Subject: Finding of No Significant Impact (FONSI) for Baldwin High School Library
TMK: 3-8-007: 004, 047
Wailuku, Maui, Hawaii

FINAL ENVIRONMENTAL ASSESSMENT

BALDWIN HIGH SCHOOL LIBRARY

BALDWIN HIGH SCHOOL LIBRARY

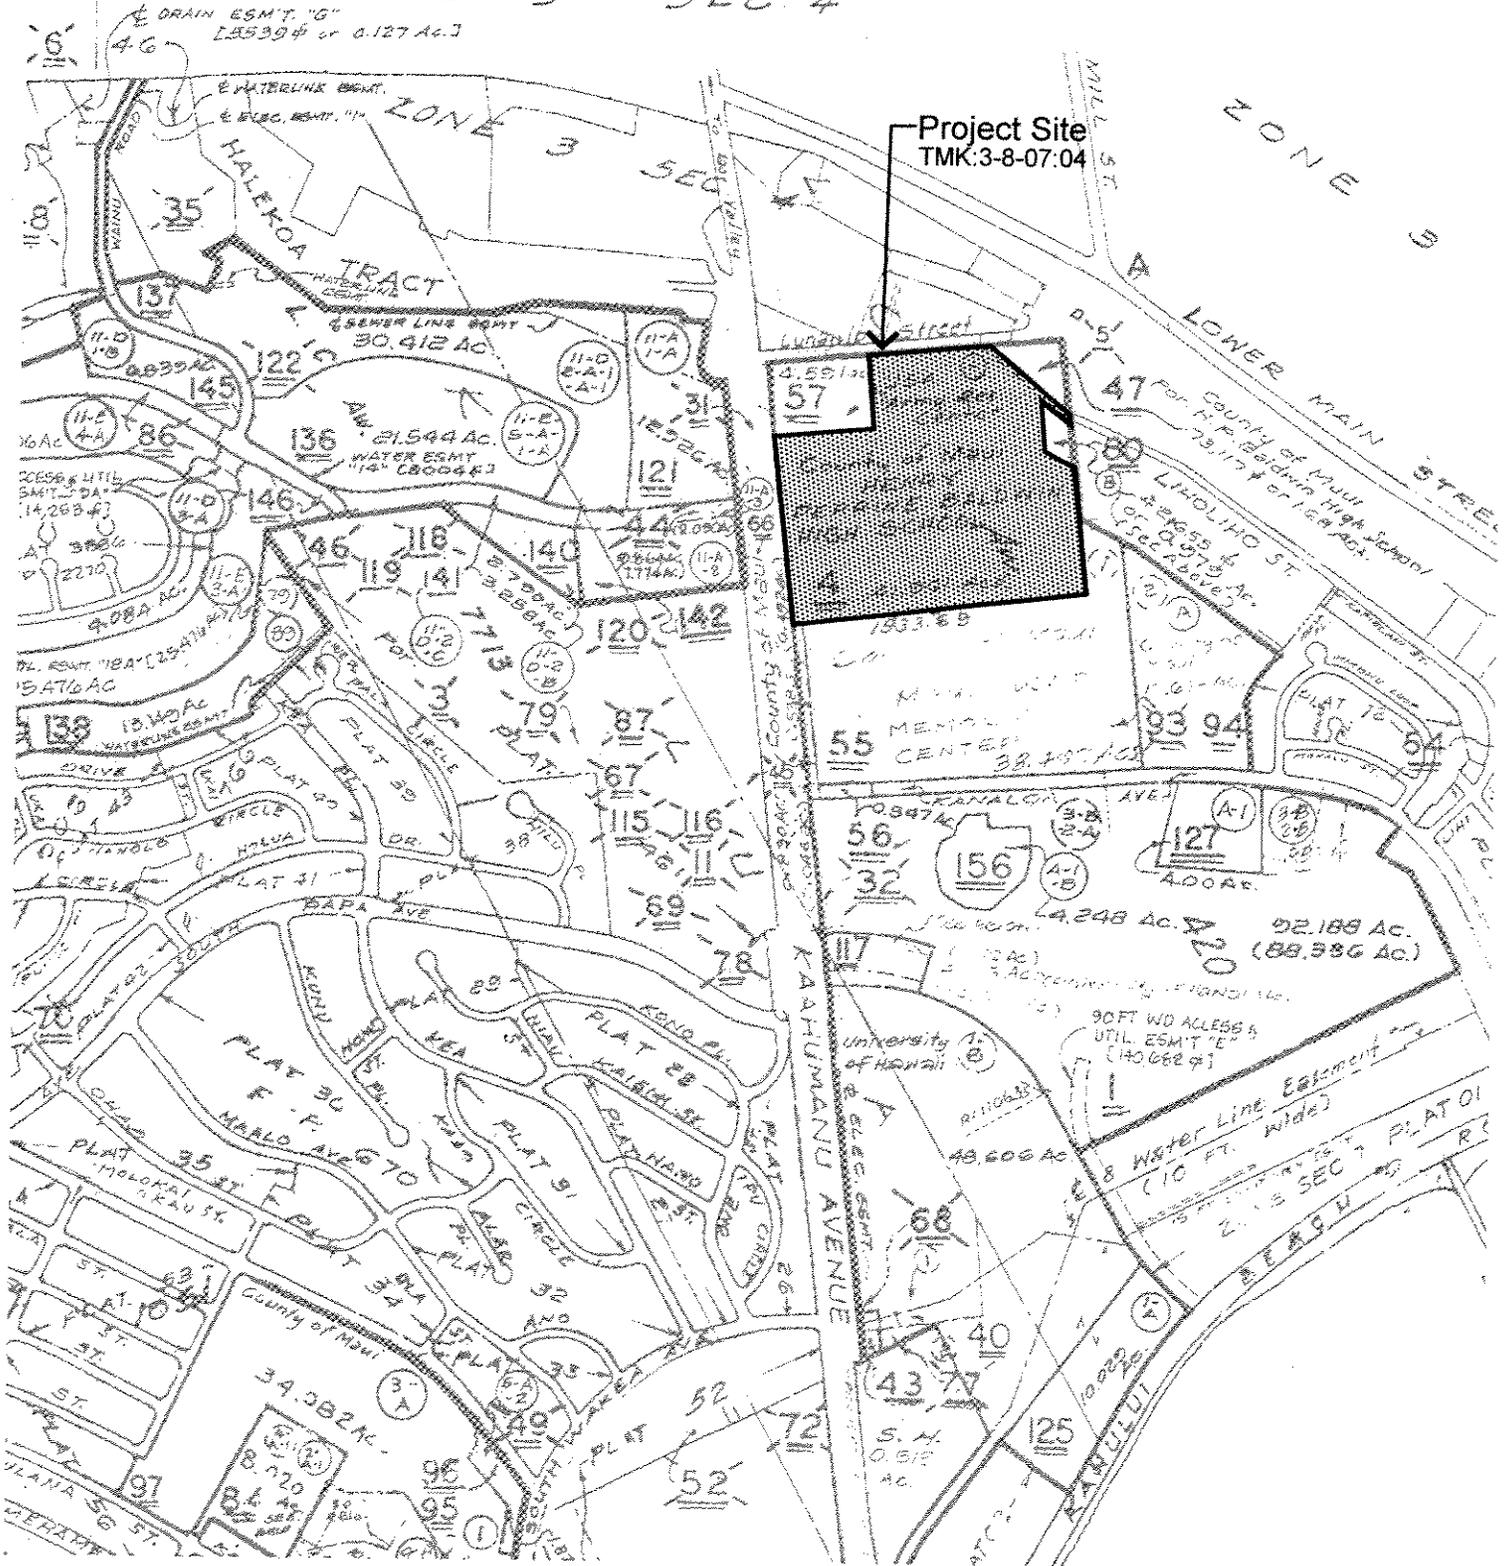
Page 4, Figure 1: Please include a larger site map of the Baldwin High School Library parcel which includes topographic information.

3. The exact age of the Chinese banyan has not been determined but it is estimated to be at least 50 years old or slightly older.
4. The site plan for the library shown in Figure 3 is adequate. Topographic information is shown on Figure 3.

Site Plan

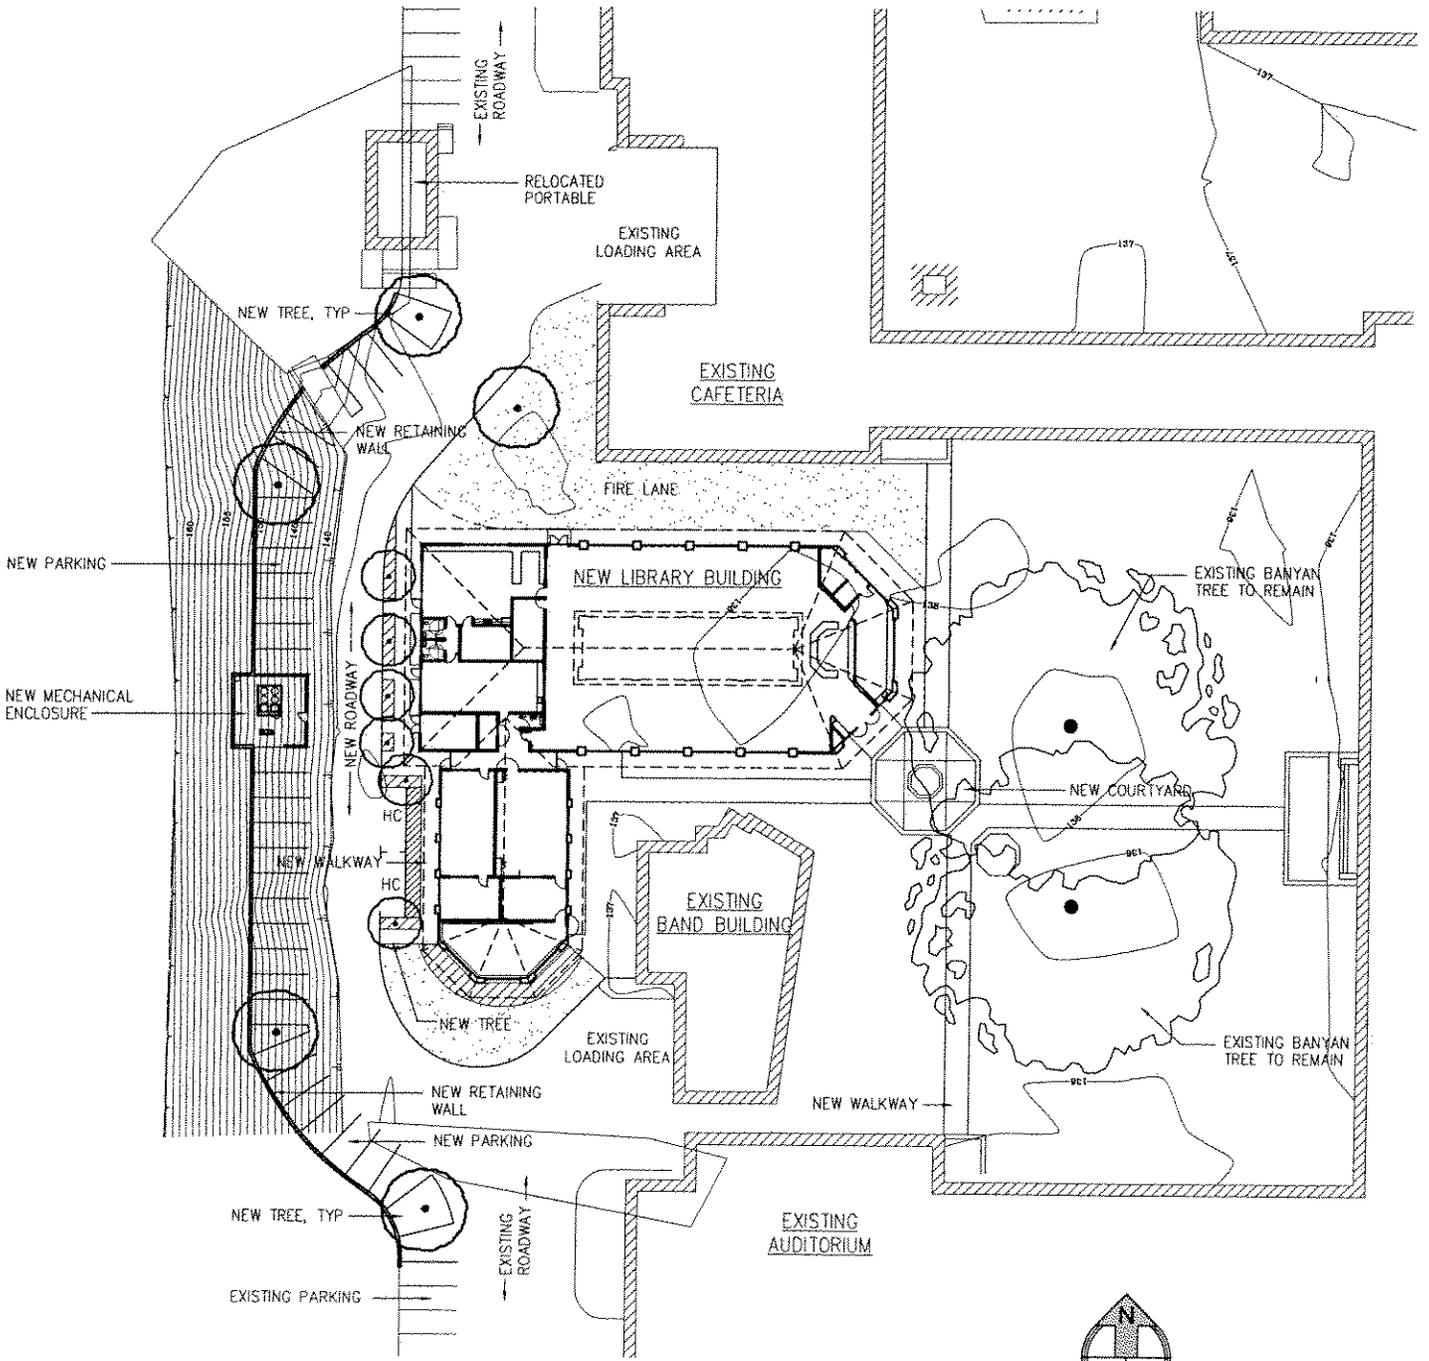
Page 2, Section 1, Description of the Proposed Action, B. Technical Characteristics, 1. Library and Media Wing, paragraph 3, lines 3-5: Please explain the specific location of the walled enclosure for mechanical equipment and provide graphic representation of its location.

Page 6, Figure 3: Please include a functional plan of Baldwin High School, such as a larger version of the site plan which is presented on page 11 of the DEA to designate photo views.

2. The walled enclosure for mechanical equipment will be constructed at the same grade as the relocated parking stalls. Its specific location has not yet been determined but it will be located in the general vicinity graphically shown in plan view on Figure 3.

5. A plan of the Baldwin High School Campus has been included in the discussion of alternative sites. A graphic depicting the location of the alternative sites considered for the library was omitted from the Draft Environmental Assessment but included in the Final Environmental Assessment.
